**Pier 40 Structural Restoration – Phase 3
Invitation for Bids (IFB)
Project/Contract #C4873
Addendum No. 1
January 3, 2019**

- 1. The above referenced IFB is hereby amended to include the Site Logistics Plan attached hereto as Attachment A.**
- 2. Sheet S502 (Concrete Repair Schedule) of the Issued for Bid Drawings in the above referenced IFB is hereby deleted in its entirety and replaced with Attachment B herein.**
- 3. All requirements of the original IFB shall remain in full force and effect, except as set forth in this Addendum and any other previously issued Addenda.**
- 4. All capitalized terms set forth in this Addendum shall have the same meaning as set forth in the IFB being amended hereby.**

AMENDED AND RESTATED SHEET S502 – CONCRETE REPAIR SCHEDULE

NOTES

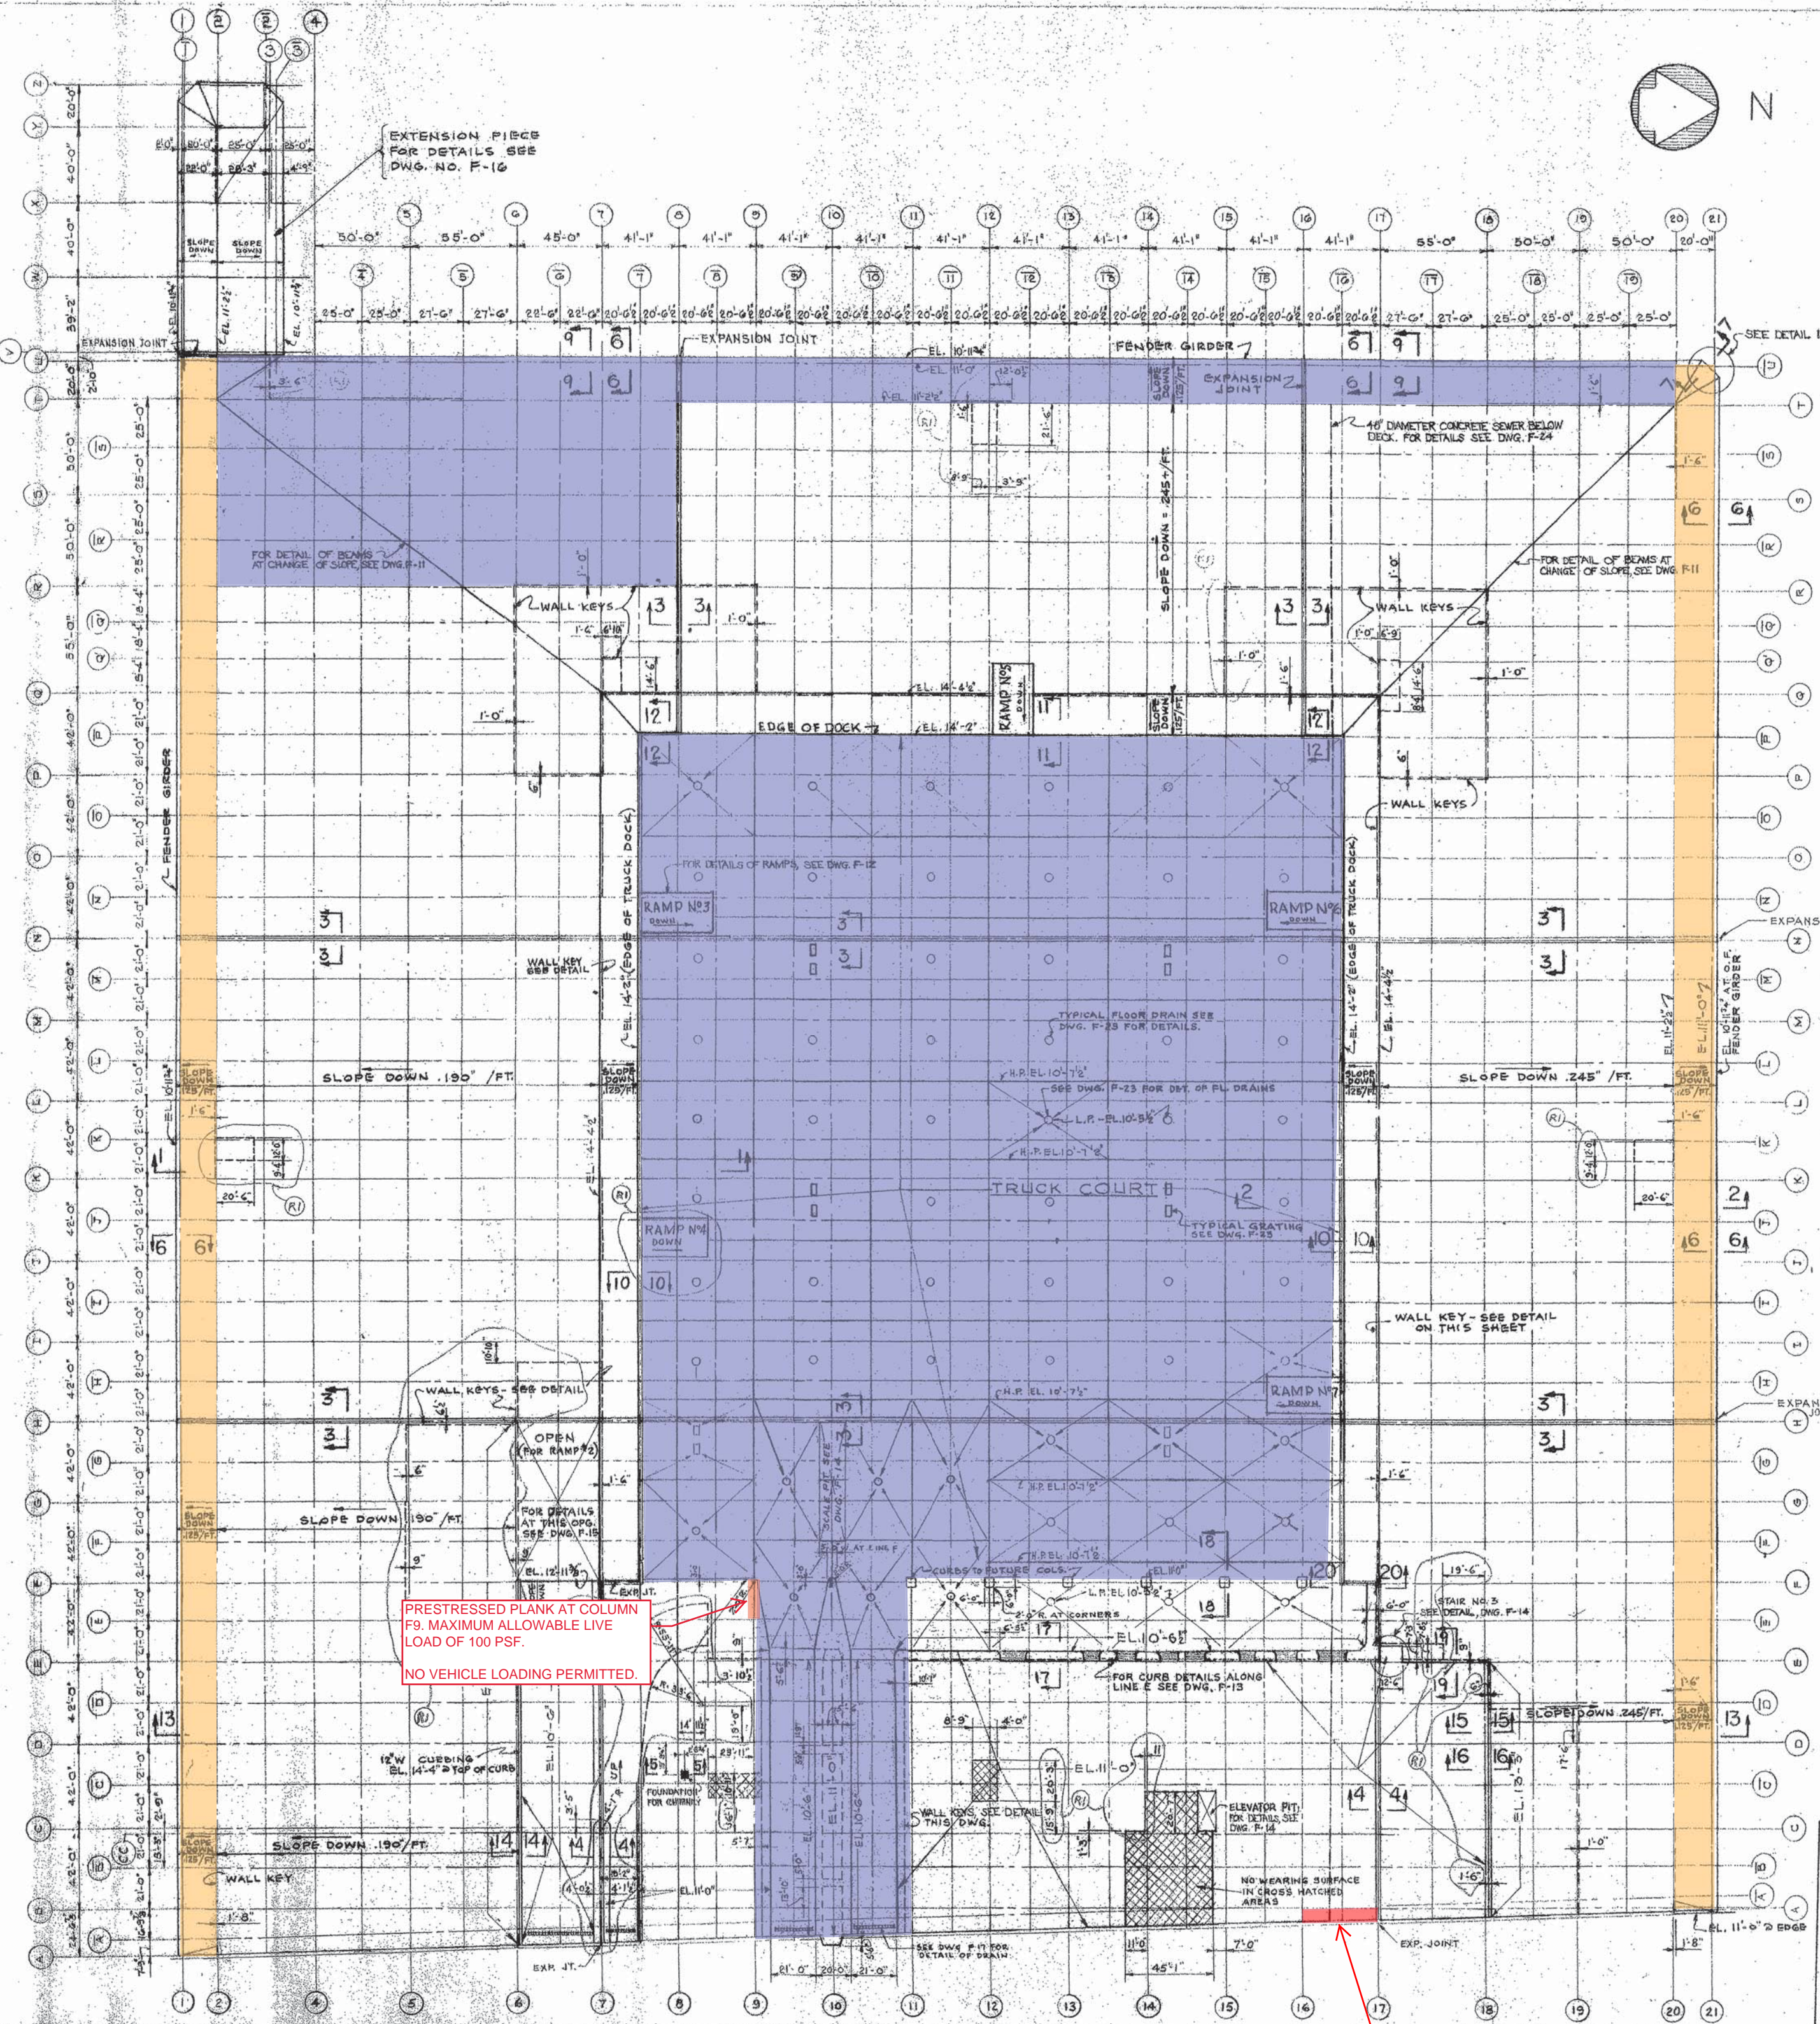
Install temporary fencing and gate under C4873 contract. This shared (C4873 & C4874) staging area is to be used for a construction trailers, etc

The concrete trucks and other construction vehicles can only travel on the pier and in front of the building when accompanied by two flagmen (front and back)

In the event of temporary closure of any public spaces on the pier, such as during a concrete pour, the contractor is responsible for set up and removal of detour barricades and signs.

North Pier apron will not be available for concrete pour staging (see Work Restrictions section of the project manual).

No dive equipment mobilization the pier aprons will be allowed. All staging is to be located on barges (see Work Restrictions section of the project manual)

C4874 concrete pump shall be set-up inside the pedestrian tunnel. C4874 discharging concrete trucks shall occupy a 11'x35' sidewalk area as shown. Maintain pedestrian access through the tunnel at all times during the concrete pour, inclusive of pedestrian shielding adjacent to the pump.

C4874 contractor will set up and remove temporary barricades and signs for pump and truck staging for each concrete pour day.

C4874 contractor is to relocate the jersey barrier, fence, and one gate approximately 5' east of the current location

Existing floating docks, ramp, and platform are to be removed by C4873 contractor, guide piles extracted. All salvaged materials relocated and reinstalled in the same configuration appropriately 240' east of the current location. The components to be removed and relocated are as follows:

1. 13.5'x7' timber platform
2. Two 30'x10' wood/plastic docks
3. 25'x3' aluminum ramp
4. Ten (10) 12" diameter (80' long) steel guide piles
